Amendment No. 39
License No. DPR-35

ATTACHMENT TO LICENSE AMENDMENT NO. 39

SAFETY EVALUATION BY THE OFFICE OF NUCLEAR REACTOR REGULATION
SUPPORTING AMENDMENT NO. 39 TO FACILITY OPERATING LICENSE NO. DPR-35

PILGRIM NUCLEAR POWER STATION, UNIT NO. 1

FIG. 3.1-9

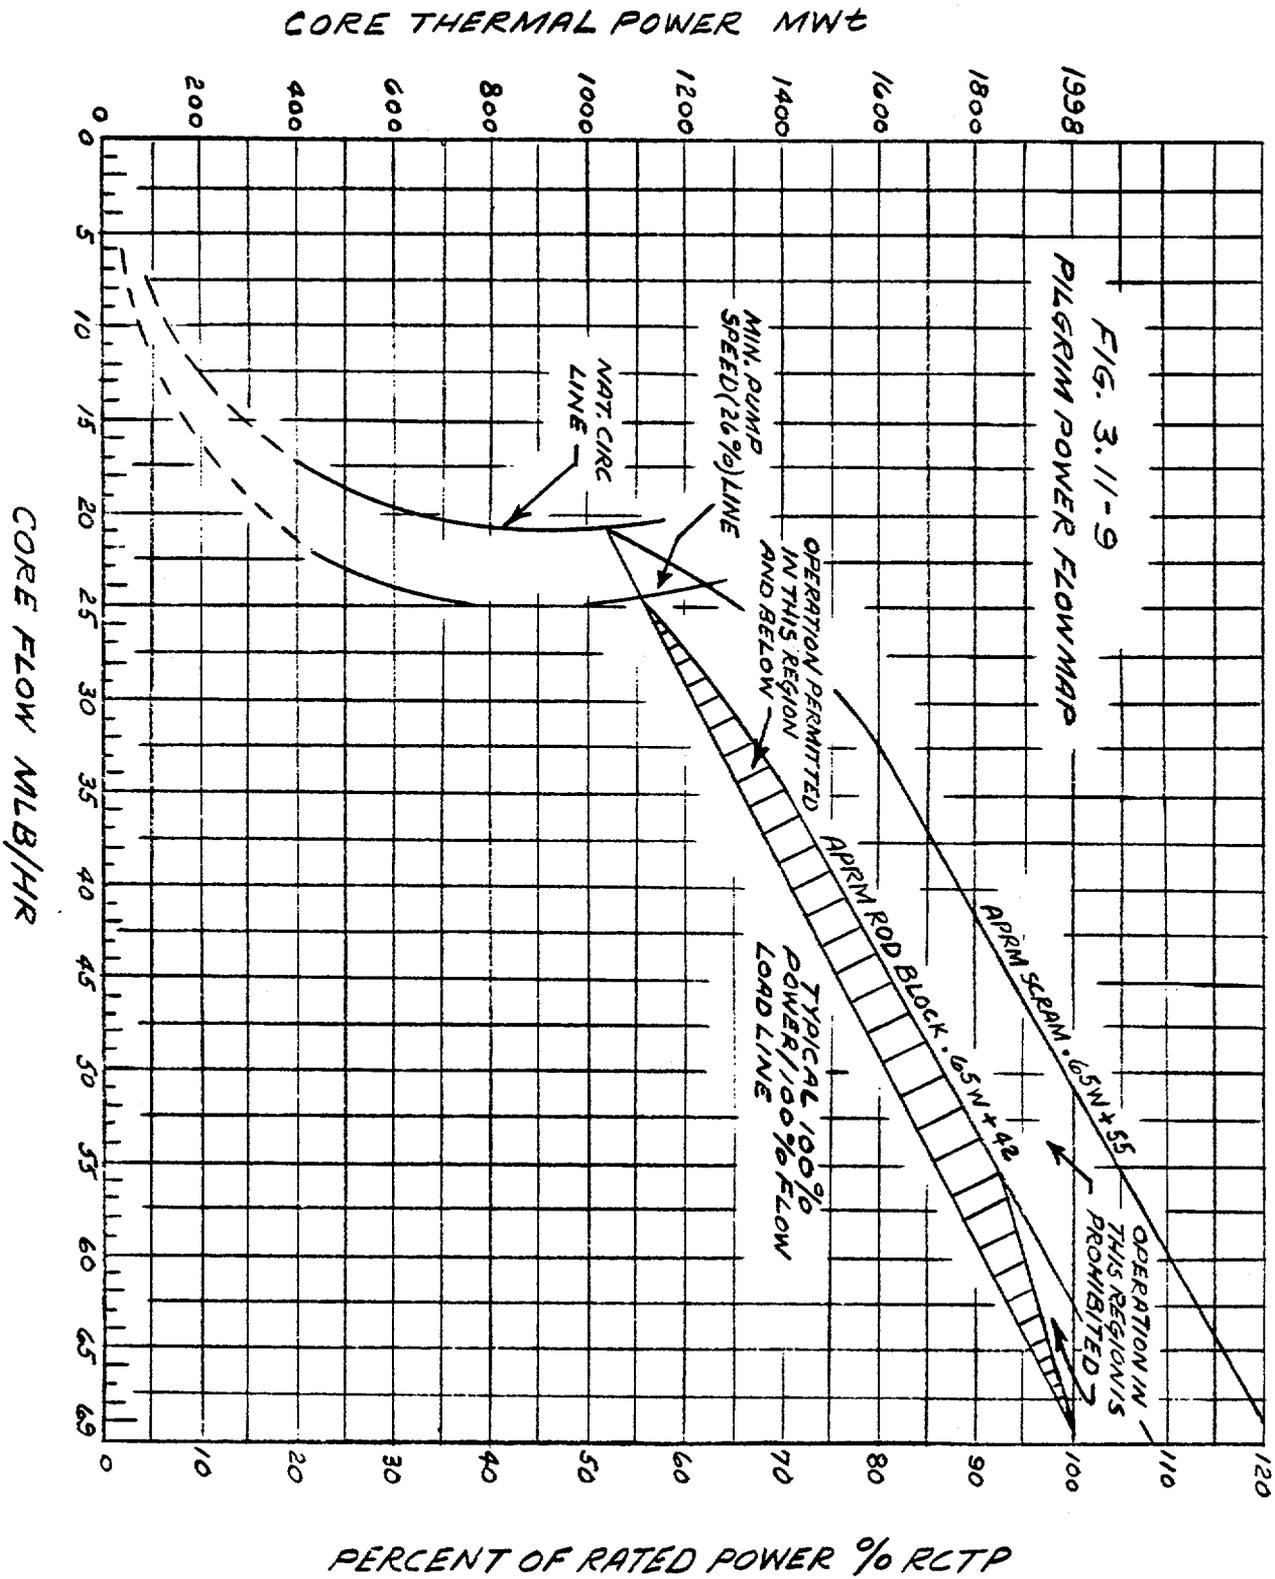
The power/flow relationship shall not exceed the limiting values shown in Figure 3.11-9. If at any time during power operation it is determined by normal surveillance that the limiting value for the power-flow relationship is being exceeded, action shall be initiated within 15 minutes to restore operation to within the prescribed limits. If the power/flow relationship is not returned to within the prescribed limits within two (2) hours, the reactor shall be brought to the Cold Shutdown condition within 36 hours. Surveillance and corresponding action shall continue until reactor operation is within the prescribed limits.

Power/Flow Relationship Bases

The power/flow curve is the locus of core thermal power as a function of flow from which the occurrence of abnormal operating transients will yield results within defined plant safety limits. Each transient and postulated accident applicable to operation of the plant was analyzed along the power/flow line. The analysis justifies the operating envelope bounded by the power/flow curve as long as other operating limits are satisfied. Operation under the power/flow line is designed to enable the direct ascension to full power within the design basis for the plant.

By letter dated December 28, 1977 BECo provided the staff with technical justification for operation limited by a rod block intercept line at power and flow conditions greater than the nominal 100% power/flow control line and less than the current rod block line. Operation in this manner provides additional flexibility for power ascension while still complying with procedures to reduce pellet-clad interaction (PCIOMR's). The licensee believed that operation within the extended envelope is compatible with the current Technical Specifications. BECo, therefore, intended to make use of the added flexibility during power ascension methods and the effect of this change on abnormal operational transients has been considered for the Pilgrim Nuclear Power Station (PNPS).

PNPS has shown that the change in power ascension methods do not significantly affect the consequences for any transient or accident previously analyzed and accepted by the NRC. On this basis we find this proposal acceptable with the provisions that (1) a Technical Specification be added to limit the power/flow conditions to within the analyzed limits as suggested in the text, and (2) a RWE analysis must be performed or appropriate justification provided for future cycles which ensures that the change in critical power ratio (Δ CPR) for a RWE from conditions on the rod block intercept line does not exceed the Δ CPR for an RWE from 100% power/100% flow conditions.
